D3.3 comments on SMF clauses

Pete Anslow, Ciena

IEEE P802.3bs Task Force, SMF Ad Hoc, 22 August 2017

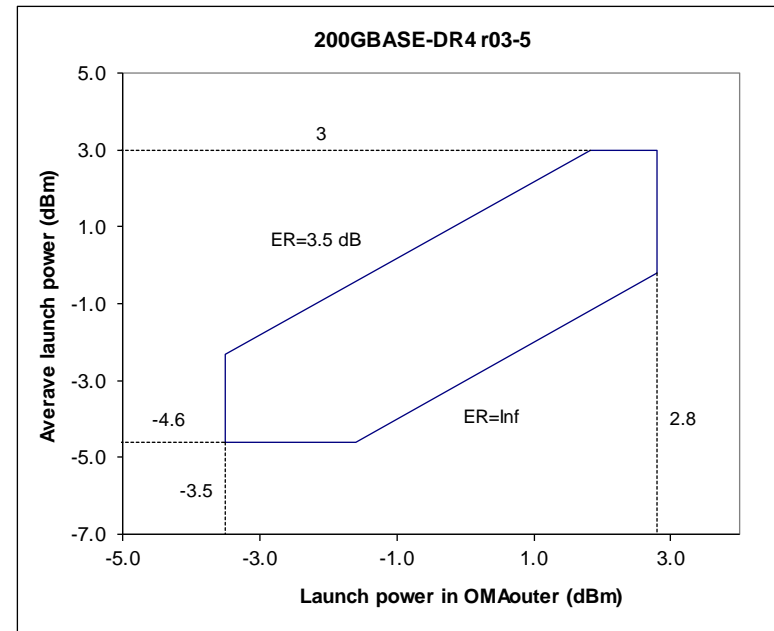
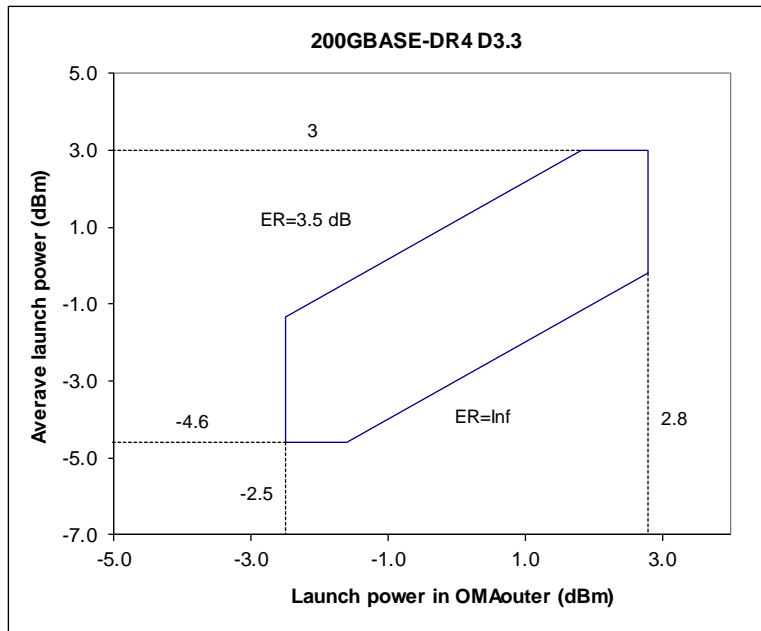
In table 121-6 propose reducing OMA_{outer} each lane min from -2.5 dBm to -3.5 dBm, and revising note b to read "Even if the TDECQ < 0.9 dB, the OMA_{outer} (min) must exceed this value". This allows for high bandwidth transmitters than can achieve lower TDECQ mins than the current stated minimum to operate at lower power, which can improve transceiver power consumption, yield, and cost. See supporting presentation for more details.

These comments between them propose for all of the single-mode PMDs in the draft to reduce OMA_{outer}, each lane (min) by 1 dB and reduce the “minimum” TDECQ by 1 dB.

In table 121-6 propose reducing OMA_{outer} each lane min from -2.5 dBm to -3.5 dBm, and revising note b to read "Even if the TDECQ < 0.9 dB, the OMA_{outer} (min) must exceed this value".

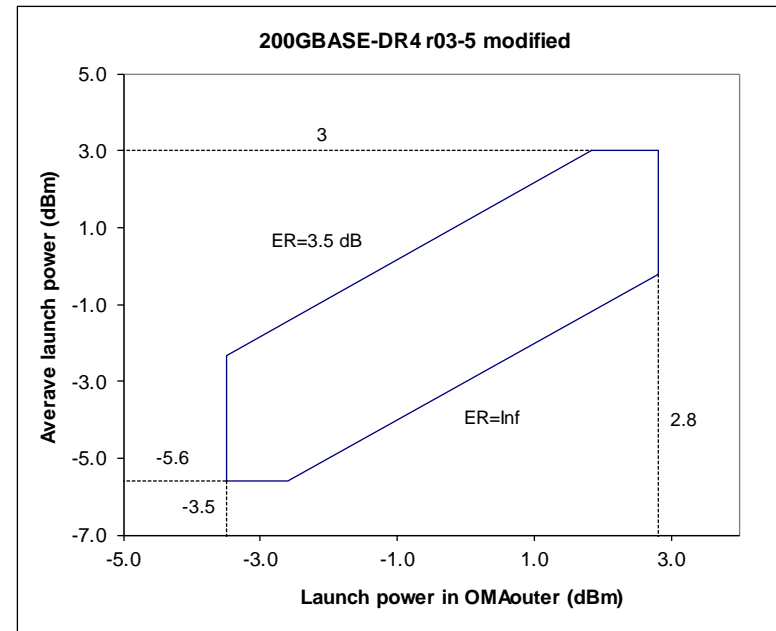
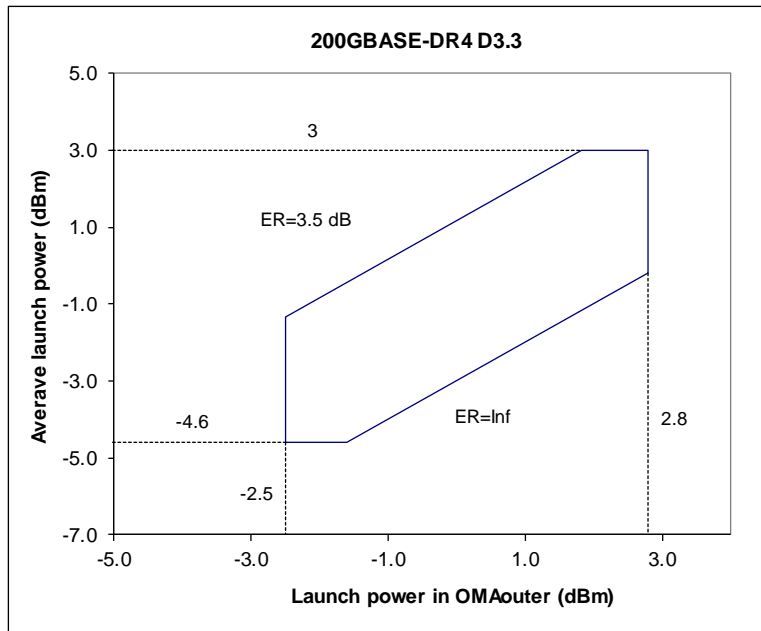
If accepted, these comments would change the effective minimum ER at the minimum $\text{OMA}_{\text{outer}}$:

- For 200GBASE-DR4 from 10 dB to 6.7 dB
- For 200GBASE-FR4/LR4 from infinite to 9.4 dB
- For 400GBASE-FR8/LR8 from infinite to 9.4 dB
- For 400GBASE-DR4 from 10 dB to 6.7 dB

If these comments are accepted, then restore the effective minimum ER at the minimum $\text{OMA}_{\text{outer}}$ by also reducing:

- Average launch power, each lane (min) in Tx table
- Average receive power, each lane (min) in Rx table

By the same amount as the $\text{OMA}_{\text{outer}}$ each lane (min) is reduced.

Figure 121-6—Stressed receiver conformance test block diagram

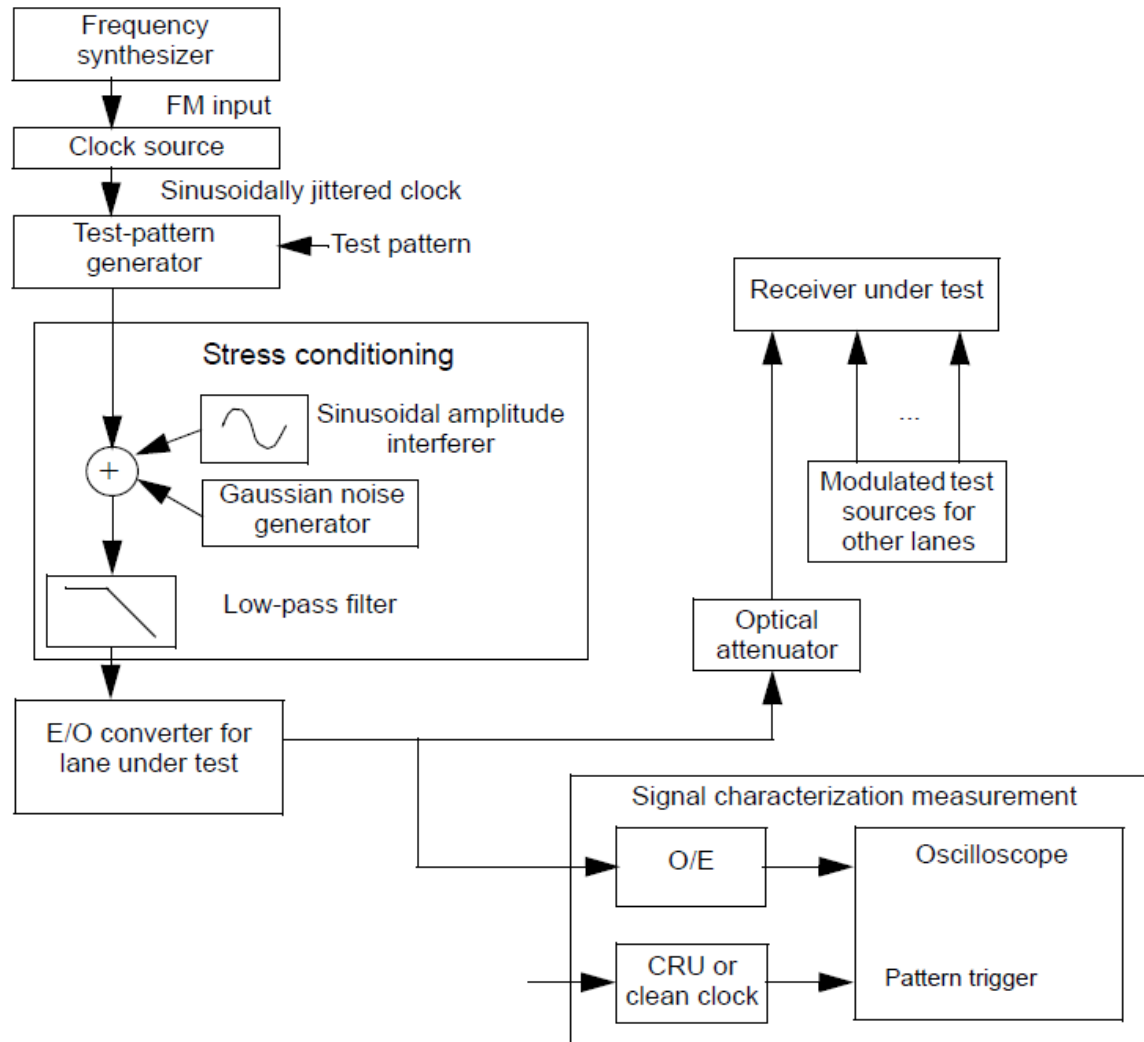
With this calibration method for stressed receiver sensitivity a receiver with wider bandwidth than Nyquist will have an improved stressed sensitivity. (around 0l.9dB if at 0.75*Baud rate). This may encourage vendors of receivers to have receiver bandwidths wider than Nyquist. However Transmitters are tested for TDECQ with the Nyquist filtered reference equalizer so that Energy above Nyquist is not "aliased" degrading their TDECQ. There will be an interoperability issue between Transmitters with bad high frequency content and Receivers which have wider bandwidth.

In Figure 121-6 move the sinusoidal amplitude interferer after the Low-pass filter. On page 299 line 54/page 230 line 1. Change " to "The sinusoidal amplitude interferer is set to 0.71*Baud rate. On page 213 line 10 change "Any remaining SECQ must be created with a combination of sinusoidal jitter, sinusoidal interference, and Gaussian noise" to "0.1dB SECQ is created with th sinusoidal interference and any remaining SECQ must be created with a combination of sinusoidal jitter, and Gaussian noise"
